February 17, 2015

PETERSBURG, ALASKA
NORDIC DRIVE REFURBISHMENT:
HAUGEN DR TO FERRY TERMINAL
PROJECT NO. STP-0003(156)~68048
PSG NORDIC DRIVE SEWER LINE IMPROVEMENTS RSA# 68112
HAUGEN DRIVE AND BIKE PATH IMPROVEMENTS
PROJECT No. 0938(4)~69518/RSA No. 68113

As-Built's
Heidi Fredrickson
Project Engineer
for Kraig Norheim
Project Engineer
3.10.20

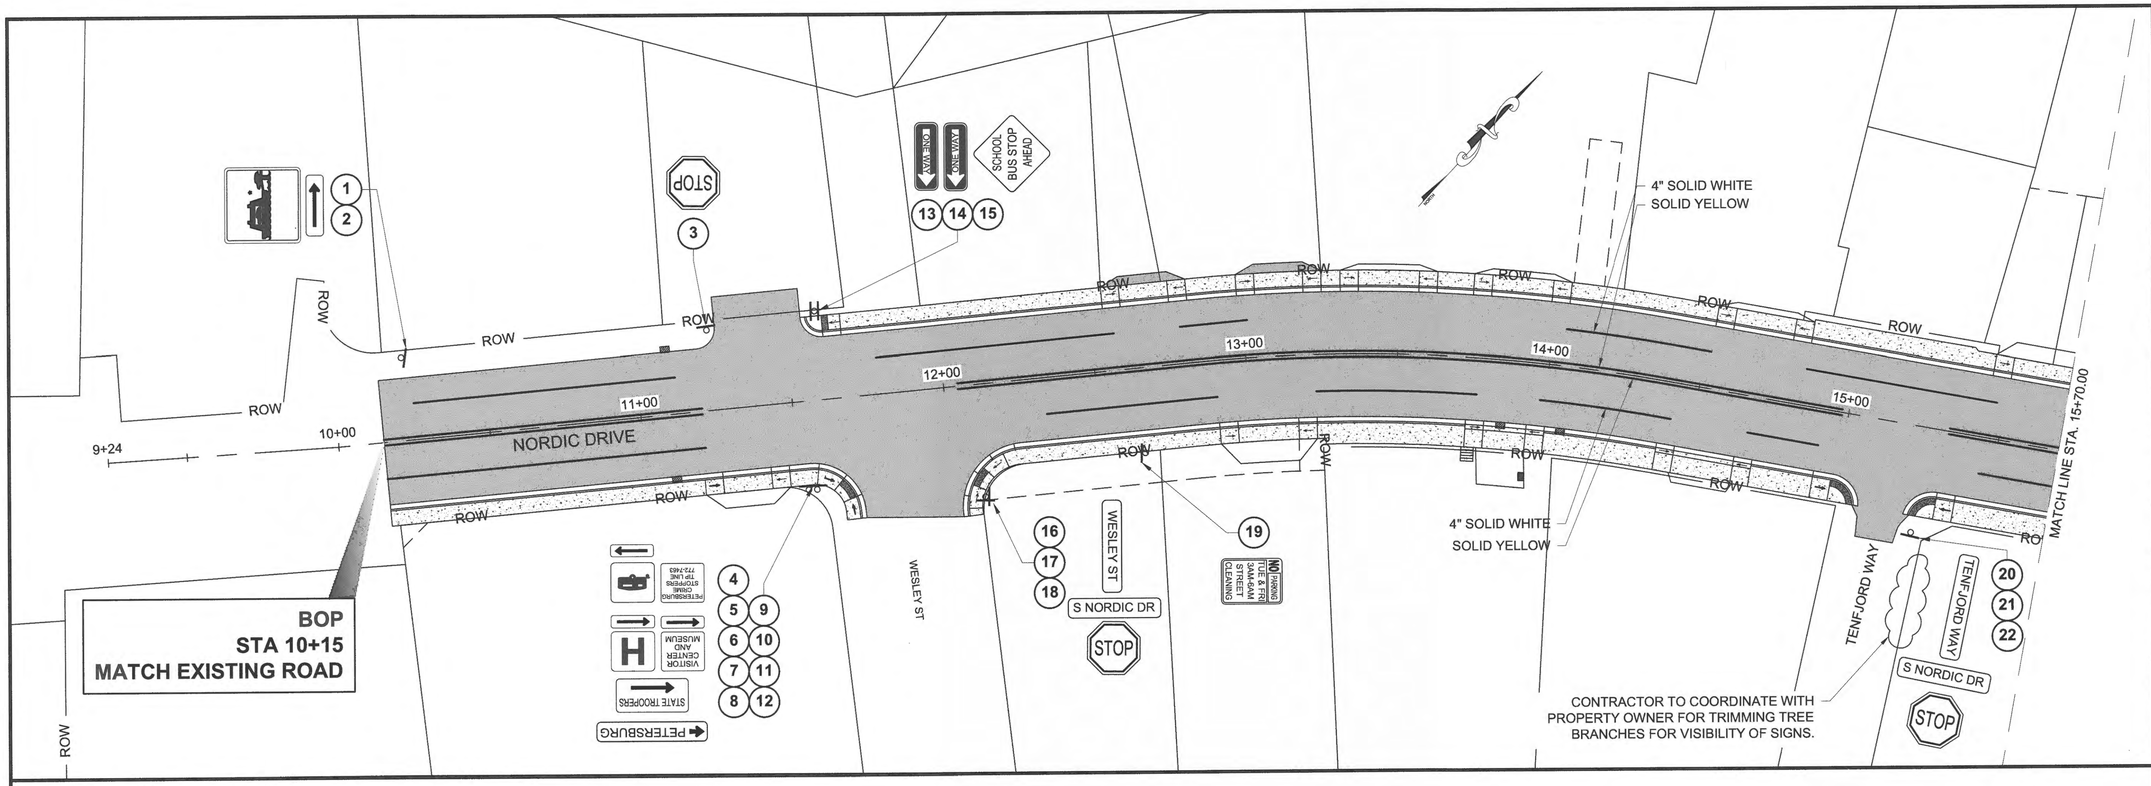
The striping done during the 2015 construction season was significantly worn off in most areas during winter shutdown and two sections of the roadway were milled and re-paved in the 2016 season, requiring the entire project be re-painted. The work includes longitudinal striping from BOP to EOP, parking spaces from BOP to 12th Street as required, and crosswalks and Stop bars per plan. A price proposal of $14,063.00 was submitted by Subcontractor Specialized Pavement Markings (Attachment 1). With the 15% Contractor's markup the total price proposed was $16,172.45, which is $903.00 more than the original bid item of $15,269.00 for Haugen Drive. The new price is 5% more to re-shoot and was accepted by the Department
